Safety of children

268 and 278 Catherine Fields Road, Catherine Fields, NSW.

Minarah College

Figure 5 and can be accessed on foot in 12 minutes.

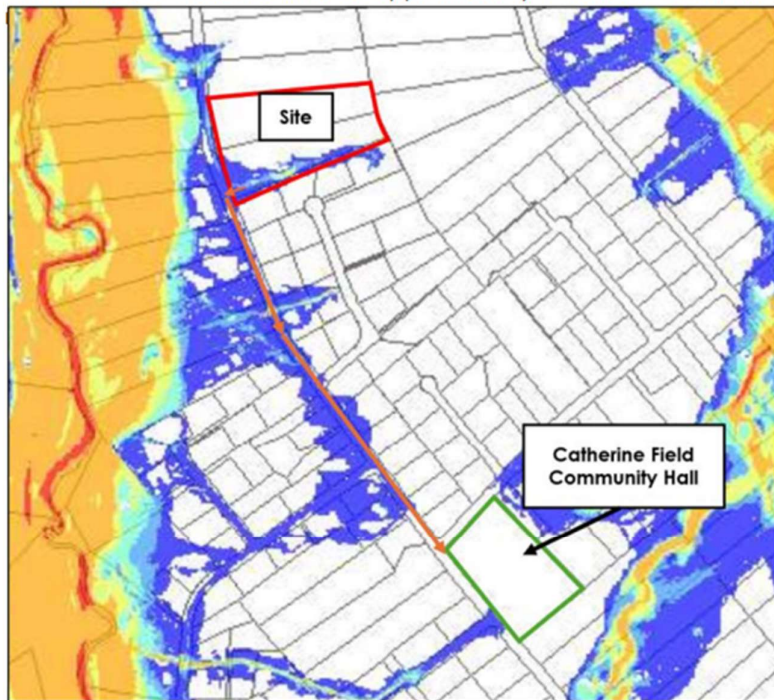
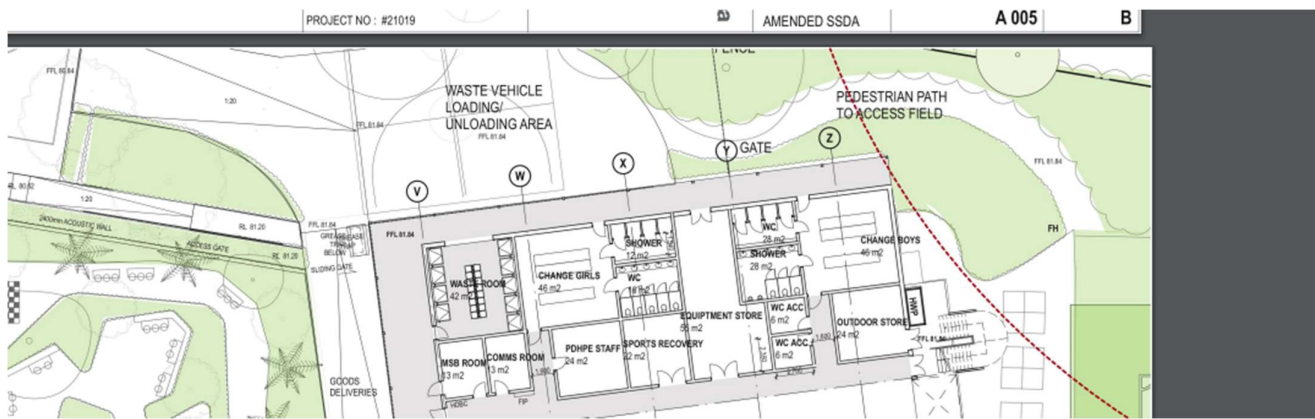
Once again, the FERP plan discusses walking students to Catherine Field hall. Why are people continuously told not to drive through flood waters yet this report says that it is safe for pedestrians. With no kerb and gutters, no street lights at night time, how is the school expected to walk 980 students safely to a community hall which only holds 120 people? Further to this, if the students are walking to Catherine Field community hall, they will be walking directly through the overland flow path which at its peak has high flows like a river and can wash away a small child. If approved, Minarah College and Martens should be held accountable for any future loss of life caused by walking students through flood waters. Have they not been made aware that due to the flooding in Catherine Fields and surrounds, people have lost their lives due to driving through flood waters on Anthony road.

The 2022 flood study shows that Catherine Fields Road is affected by H1-H4 flood hazards in the PMF event. However, there is a route between the site and Catherine Field Community Hall which is only affected by up to H2 flood hazards, which is trafficable by pedestrians but not vehicles (refer Figure 3 for definitions). Therefore, the nominated evacuation route from the site is southeast to Catherine Field Community Hall via Catherine Fields Road, a total distance of approximately 1 km. The evacuation

Although we do not recommend the use of this evacuation route, if ordered by SES or if otherwise necessary, this evacuation route can be used by pedestrians at all times, including at the peak of the PMF.
